**COMMONWEALTH OF KENTUCKY
BEFORE THE KENTUCKY STATE BOARD
ON ELECTRIC GENERATION AND TRANSMISSION SITING**

**In the Matter of the Application of Glover Creek Solar,)
LLC, for a Construction Certificate to Construct a) Case No. 2020-00043
Merchant Electric Generating Facility)**

MOTION TO AMEND PROJECT BOUNDARIES

Glover Creek Solar Context Map

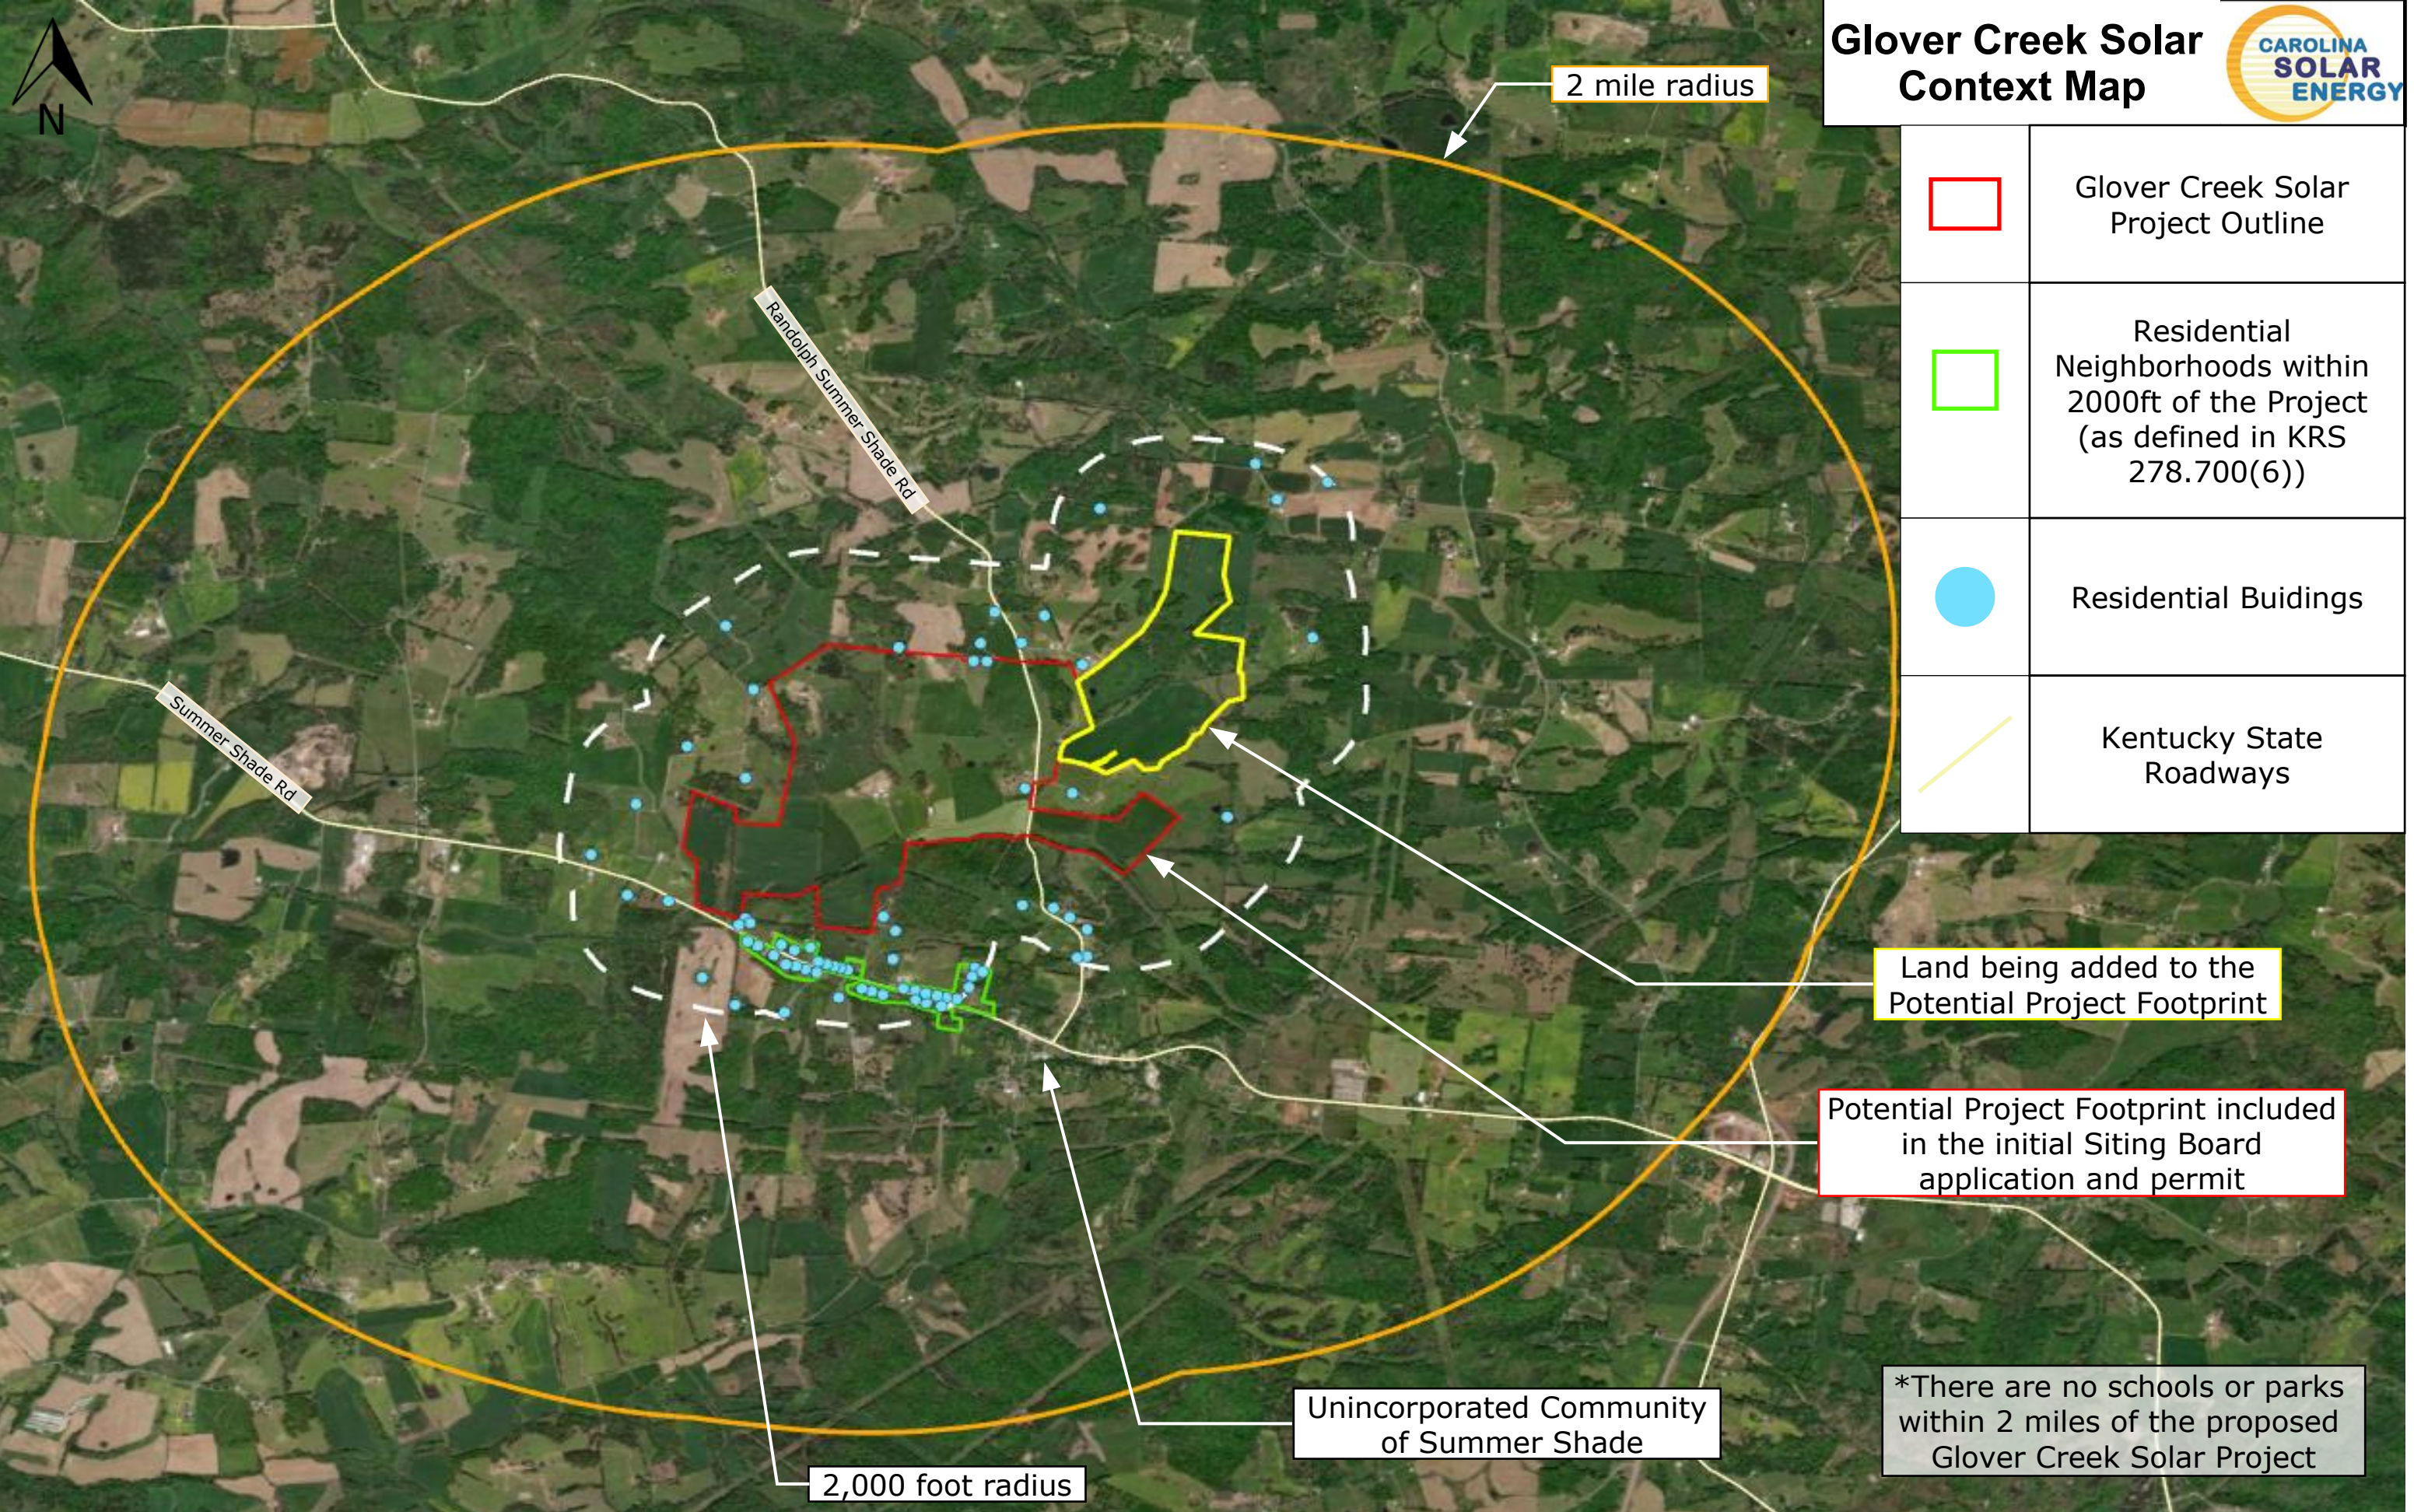
Status: An updated context map, incorporating the Sandidge parcel, is attached as Exhibit

C. There are no new residential neighborhoods within 2,000 feet of the Project, and there are still no schools, public or private parks located within a two (2) mile radius of the proposed facility.

Project. The Sandidge parcel is over 4,500 feet away from the nearest edge of the nearest residential neighborhood. The addition of the Sandidge parcel therefore does not move the Project closer, or add impact, to the residential neighborhoods. An updated Context map showing the neighborhoods and new project outline including the Sandidge parcel is attached as Exhibit C.

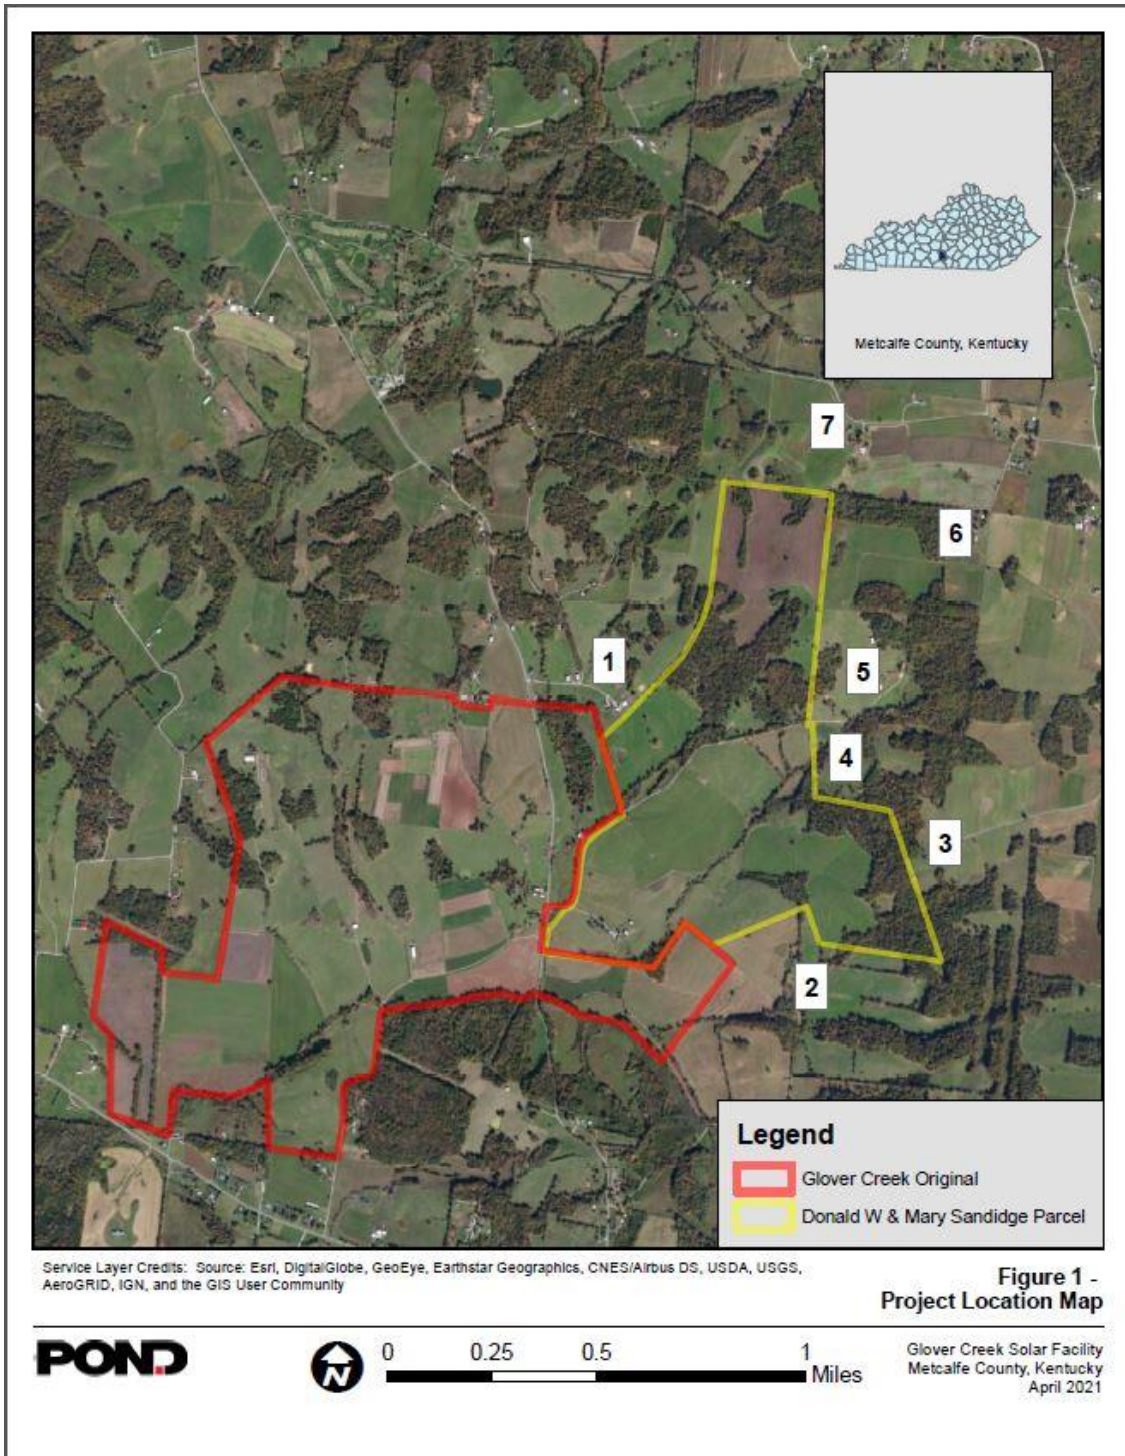
This noise addendum encompasses acquisition of land after the noise report was initially submitted. **Figure 1** (below) displays the previously analyzed project area (red outline) and additional parcel, identified as the “Sandidge Parcel” (yellow outline). Seven parcels were identified by Carolina Solar for determination of noise impacts, as they surround the Sandidge Parcel. The table below notes the approximate distance each identified noise receptor is to the Sandidge Parcel. The outer edges of the acquired parcel are used for measurement to demonstrate the highest potential noise measurement at each residence from continuously operating panels. Carolina Solar noted that all equipment will be at least 150 feet from nearby residences and 100 feet from roadways and adjoining parcels, so these values serve as worst case scenarios.

In Section 2.3.2. of the Noise Assessment, the inverters proposed for use were SMA Sunny Central UP inverters, or similar. As discussed in Section 2.3.2., the SMA Sunny Central UP inverters produce noise of 67.0 at 10 meters, which is roughly the equivalent to the hum of a

household air-conditioning unit. These inverters are considered “central” inverters and typically produce more noise than “string” inverters, which is another type of inverter commonly used in solar installations in the US.

Glover Creek Solar Nearest Residences Map

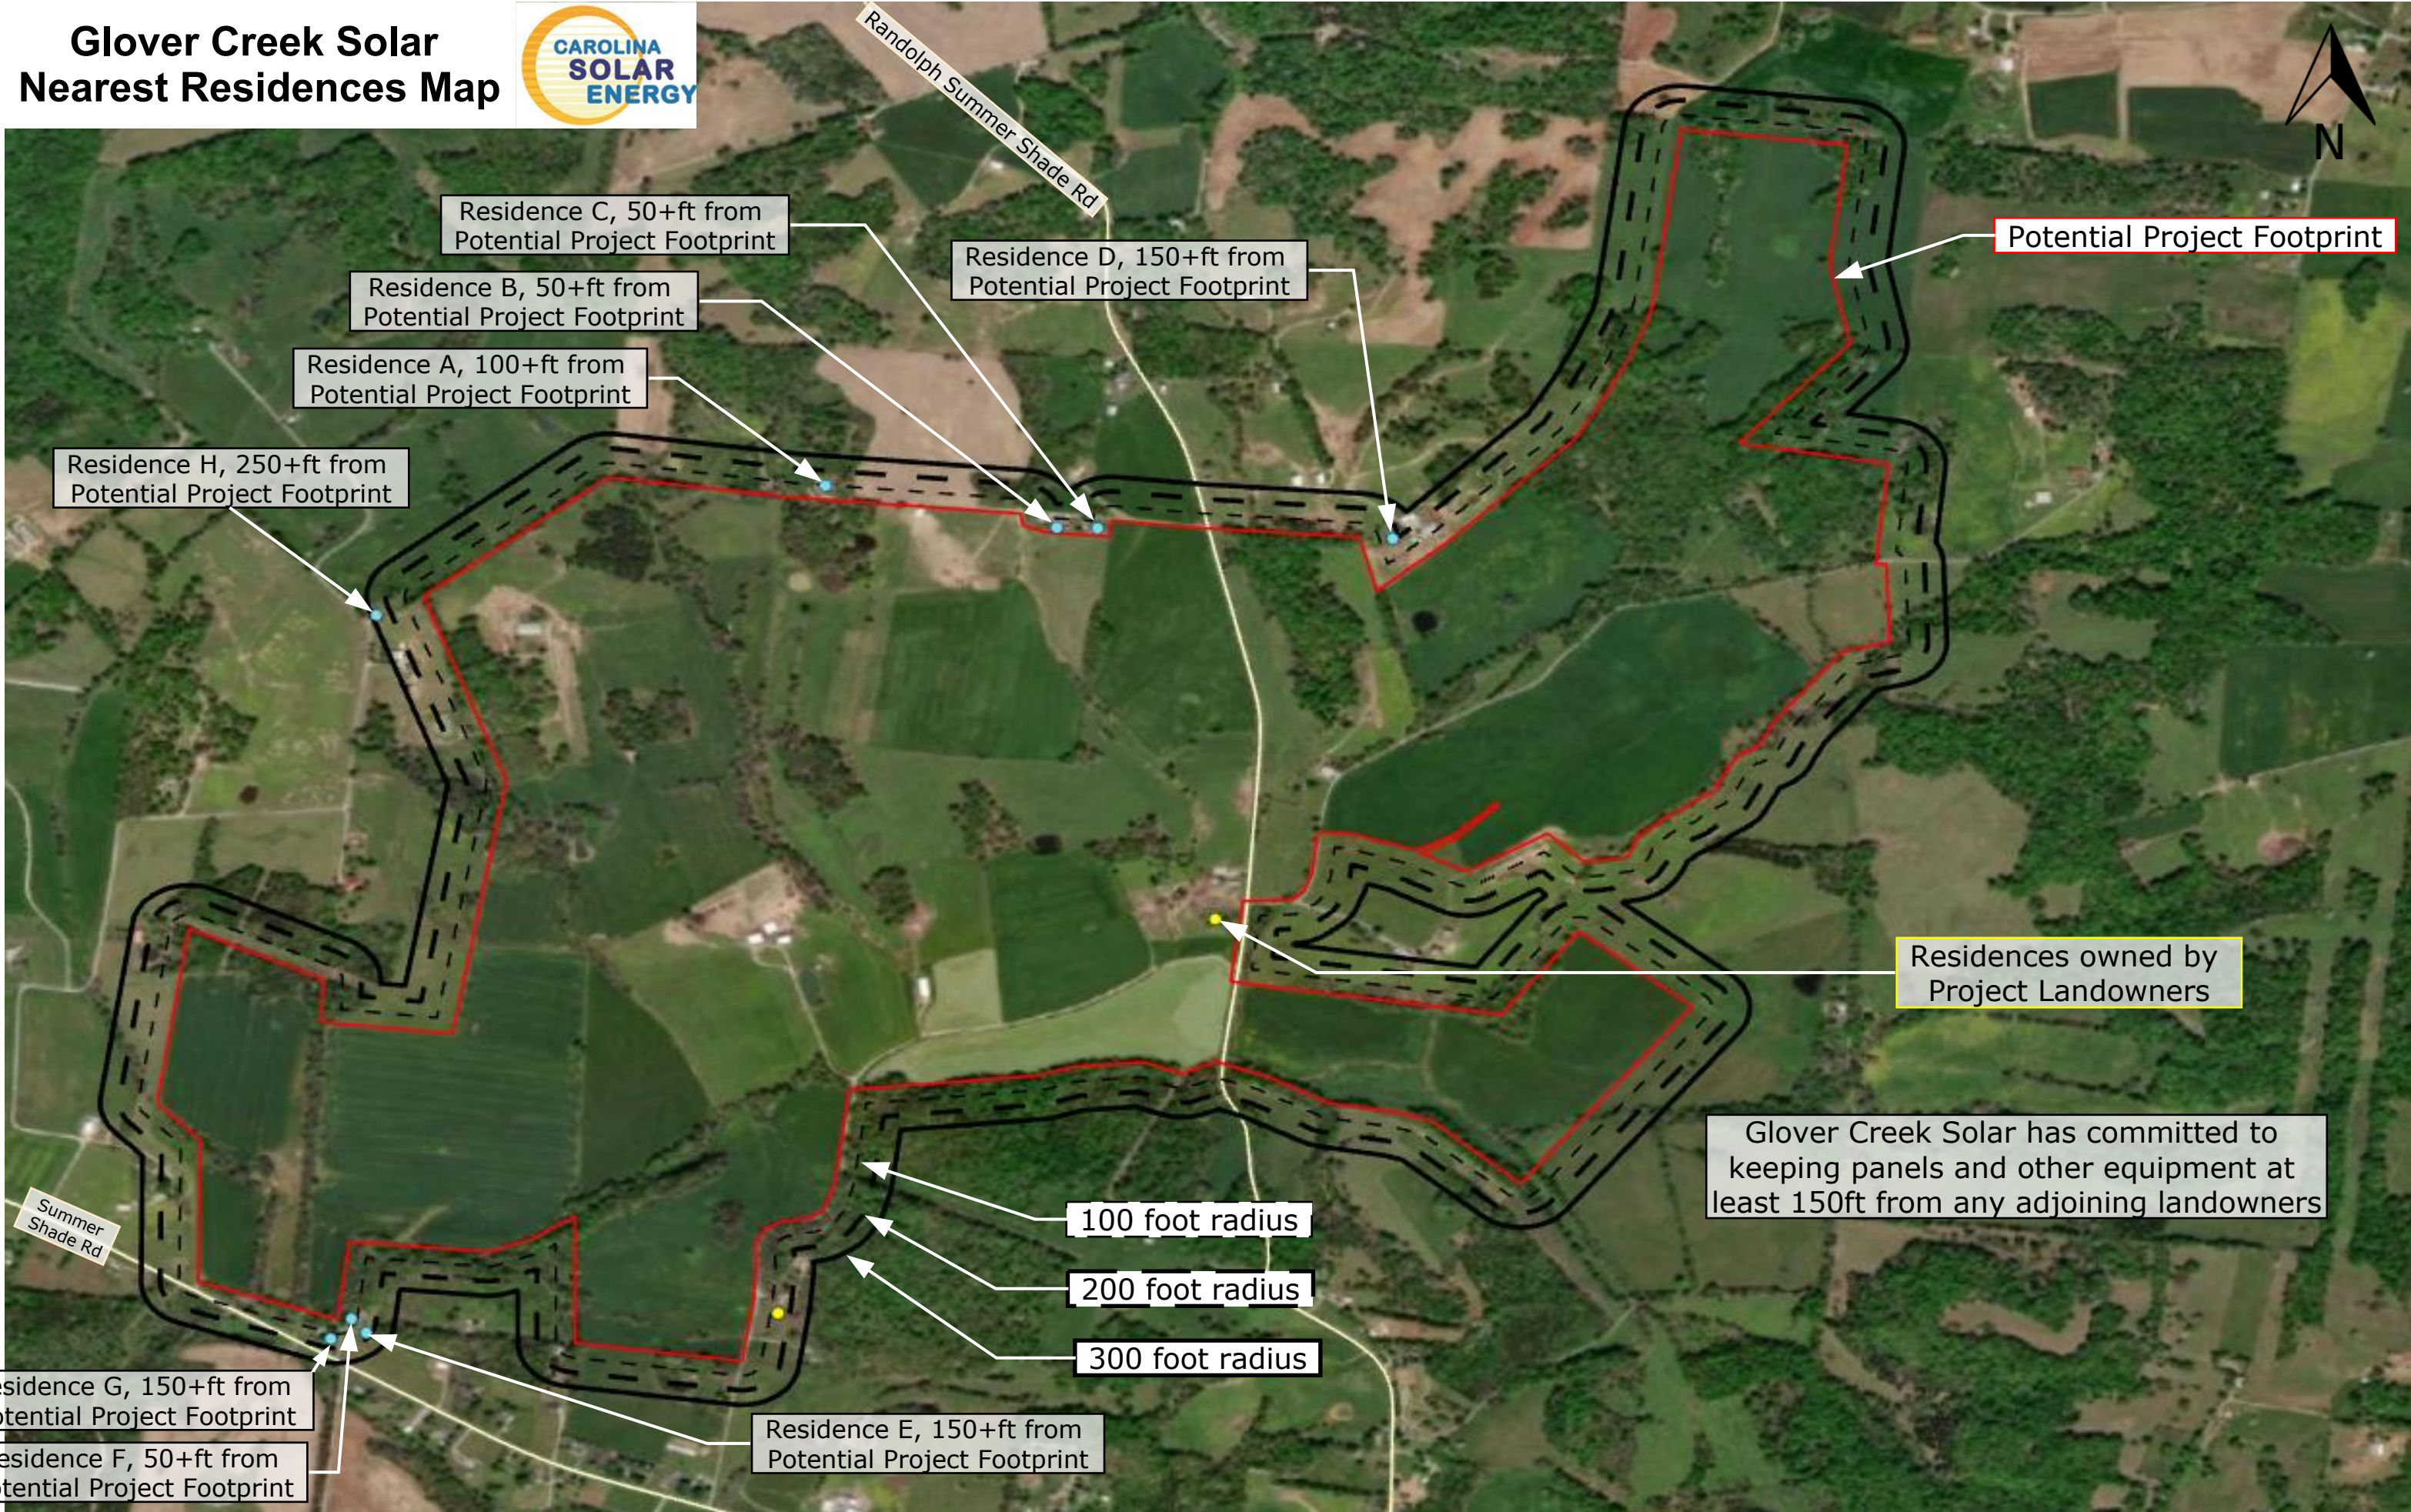
HE 2-II(B): An updated map showing residences within 300 feet is attached as Exhibit M.
